Serial: NPD-NRC-2009-064
April 6, 2009

**LEVY NUCLEAR POWER PLANT, UNITS 1 AND 2
DOCKET NOS. 52-029 AND 52-030
RESPONSE TO REQUEST FOR ADDITIONAL INFORMATION LETTER NO. 020 RELATED TO
IDENTIFICATION OF POTENTIAL HAZARDS IN SITE VICINITY**

**Levy Nuclear Power Plant Units 1 and 2
Response to NRC Request for Additional Information Letter No. 020 Related to
SRP Section 2.2.1-2.2.2 for the Combined License Application, dated March 6, 2009**

Progress Energy Florida
**Levy Nuclear Plant
 Units 1 and 2**
 Part 2, Final Safety Analysis Report
 Airports and Airways
 FIGURE 2.2.1-204 Sheet 1 of 3
 Rev. 1 Draft

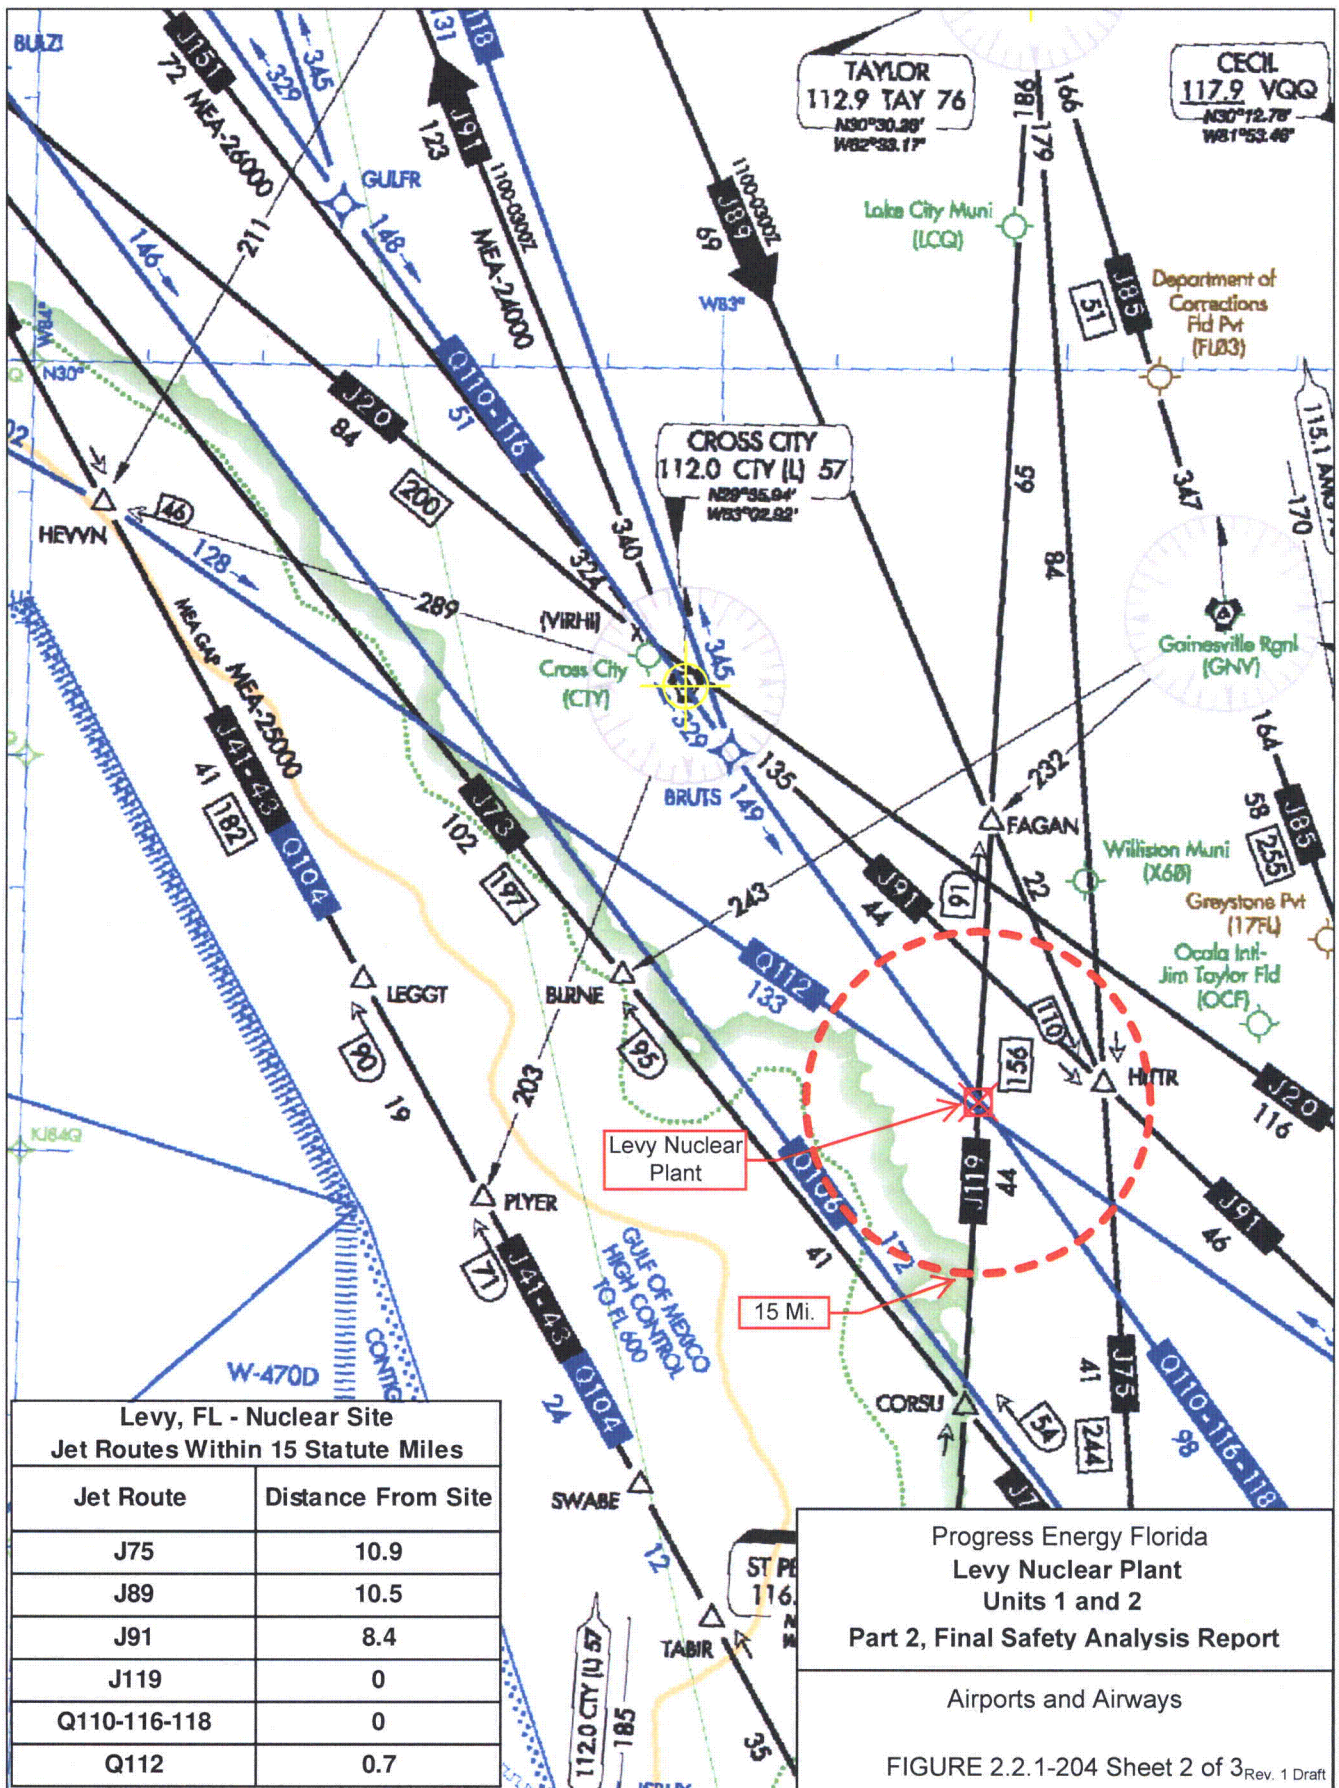
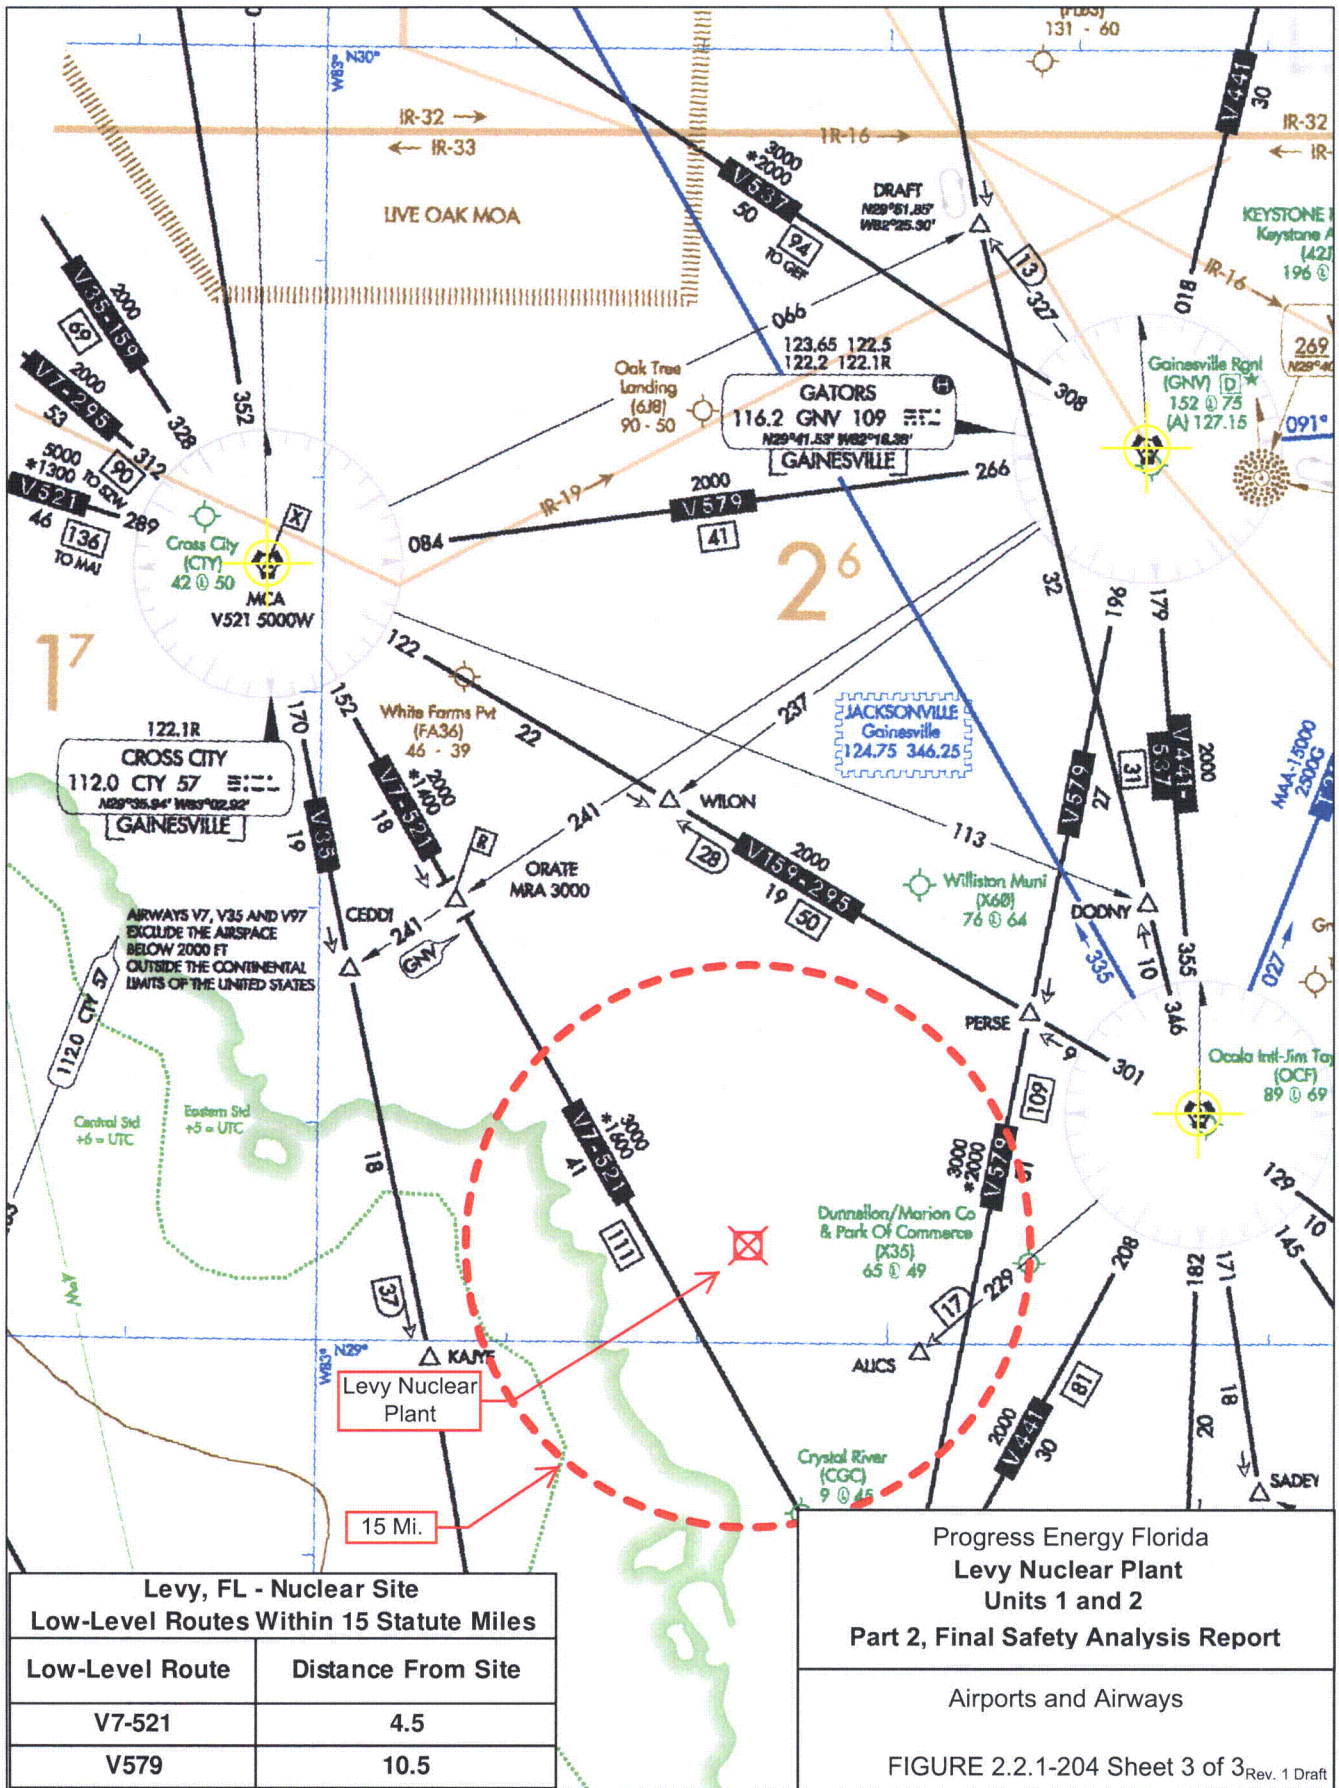
RG 1.206 provides guidance regarding the information that is needed to ensure potential hazards in the site vicinity are identified and evaluated to meet the siting criteria in 10 CFR 100.20 and 10 CFR 100.21. The NRC Staff's review of FSAR Sections 2.2.2.7 and 3.5.1.6 indicates that there two 8 mile wide Federal Victor Airways, VR 1006 and V7-521, whose center line are within 4 miles of the LNP site. Therefore, in accordance with the acceptance criteria for FSAR Section 3.5.1.6, the aircraft hazards associated with these Victor Airways should be evaluated and addressed in Section 3.5.1.6. Please provide an evaluation of each, or provide a justification for their exclusion.

There are five airways that have the outer boundary within 2 miles of the LNP site:

Airway	Distance to LNP Site from the Airway Centerline
V7-521	4.5 miles
VR 1006	3.1 miles
J119	0 miles
Q110-116-118	0 miles
Q112	0.7 miles

The boundary of each airway is 4 nautical miles from the centerline, thus, each of these airways is within 2 miles of the LNP site. Therefore, in accordance with the acceptance criteria for FSAR Subsection 3.5.1.6, the aircraft hazards associated with these airways will be evaluated. After the evaluation is completed, the associated FSAR changes will be provided to NRC by July 31, 2009. These changes will be added to the FSAR in a future revision.

"The outer boundaries of five airways are routed within 2 miles of the LNP site: V7-521, VR 1006, J119, Q110-116-118 and Q112 (shown on Figure 2.2.1-204)."

2. Replace FSAR Figure 2.2.1-204, in its entirety, with the version attached (see **Attachments/Enclosures** below). A second and third sheet have been added to Figure 2.2.1-204 that indicates the routes of Airways V7-521, J119, Q110-116-118 and Q112.
